MARIELLA ESTATES PRO JZ24-43

JZ24-43 MARIELLA ESTATES PRO PLAN WITH REZONING 18.750

Revised Initial PRO Plan: Consideration of Eligibility

Rezoning Request from RA Residential Acreage to R-1 One Family Residential with a Planned Rezoning Overlay

BRAGIOLE BROTHERS, LLC
MARIELLA ESTATES
CONCEPTUAL PLANNED
REZONING OVERLAY
TREE LIST

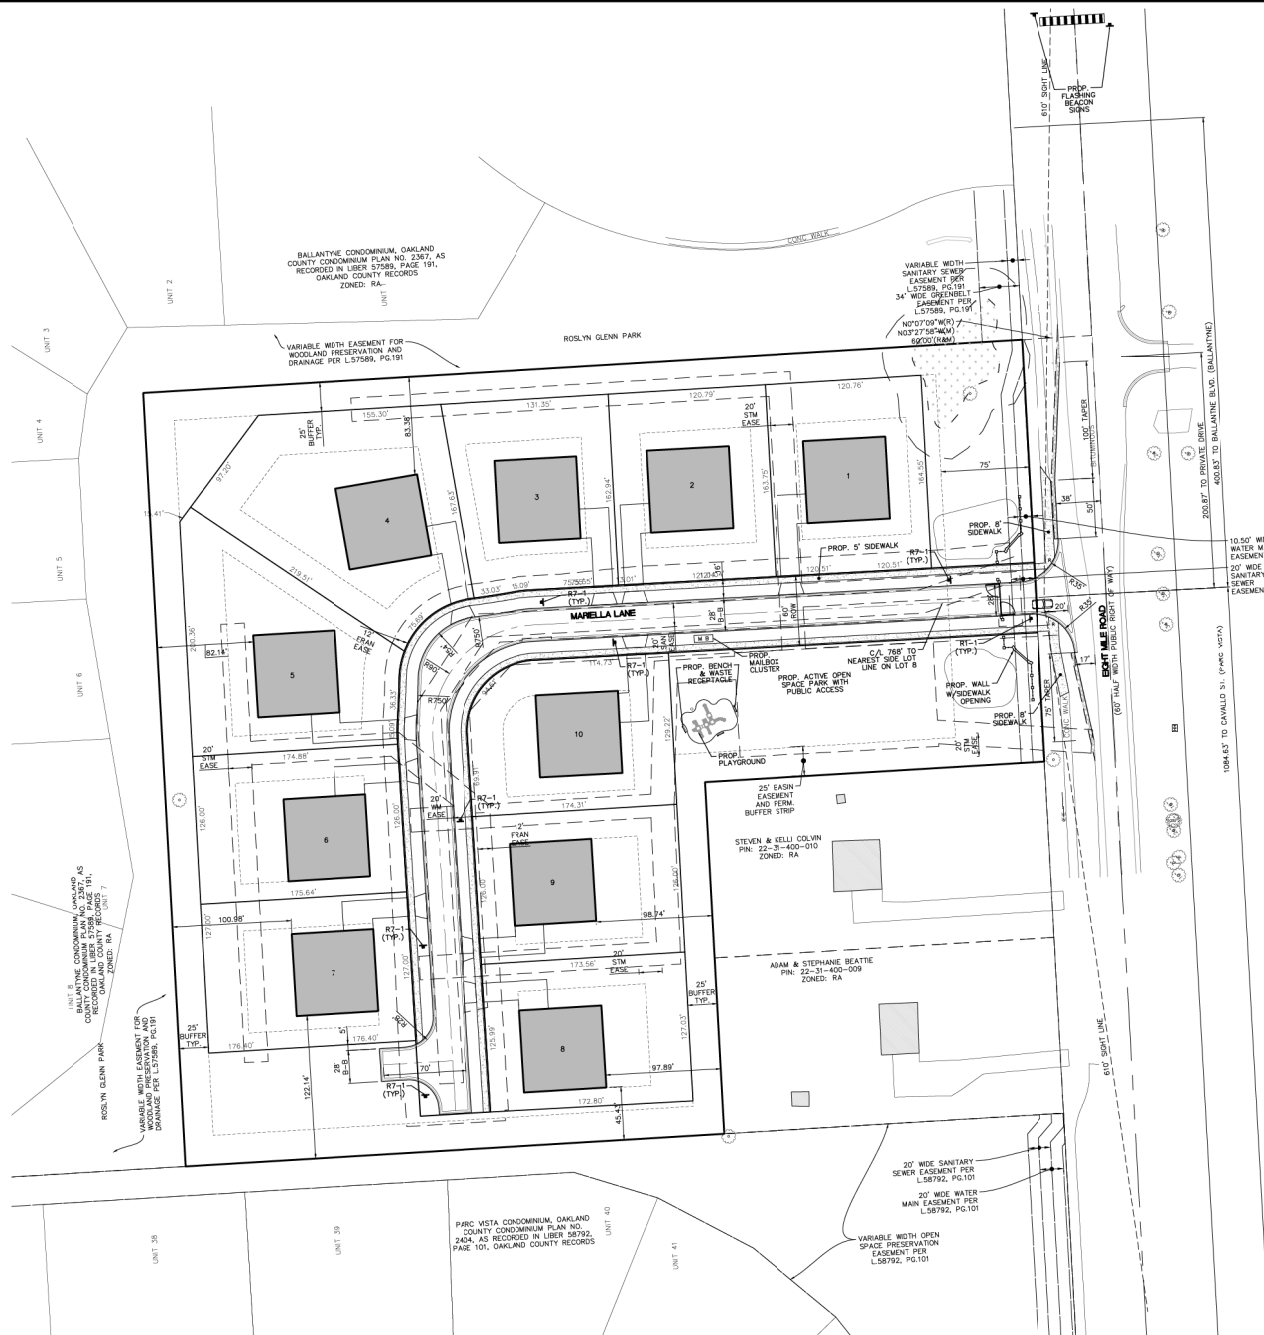
7. The applicant has stated on Sheet L-4 that they will take credit for Tree 2420 and Tree 1789 for a total of 11 credits. By taking credit for existing (non-regulated) trees, the applicant may be required to place these trees into a conservation easement (see Comment 14). Additionally, the applicant may have overcounted the number of required replacements on-site. Because the site is not a regulated woodland, only trees larger than 36 inches DBH are required to be replaced.

RAPID FLASHING BEACON EXHIBIT

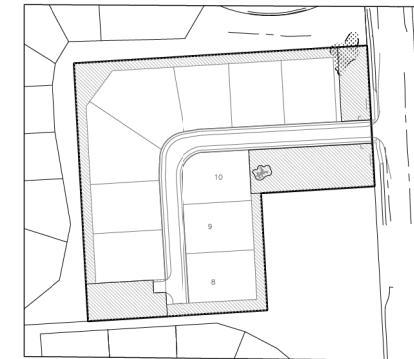
6. Flashing Crosswalk at 8-Mile: The existing 8 Mile crosswalk will be upgraded with flashing crosswalk signs. **The existing crosswalk is approximately 460 feet east of the entrance to the proposed development, and there is no paved pathway on the south side of Eight Mile Road to get users of the crosswalk to the entrance of Maybury State Park. The applicant states in their response letter that they will pursue providing a 5-foot pathway that avoids the ditch and natural features on the south side of Eight Mile. Staff has advised consideration be given to relocate the crosswalk westward, closer to the entrance of Maybury State Park, while also upgrading the crosswalk with flashing signage if a crosswalk study indicates this treatment is warranted. Road Commission for Oakland County would also need to agree to any changes to the crosswalk.**
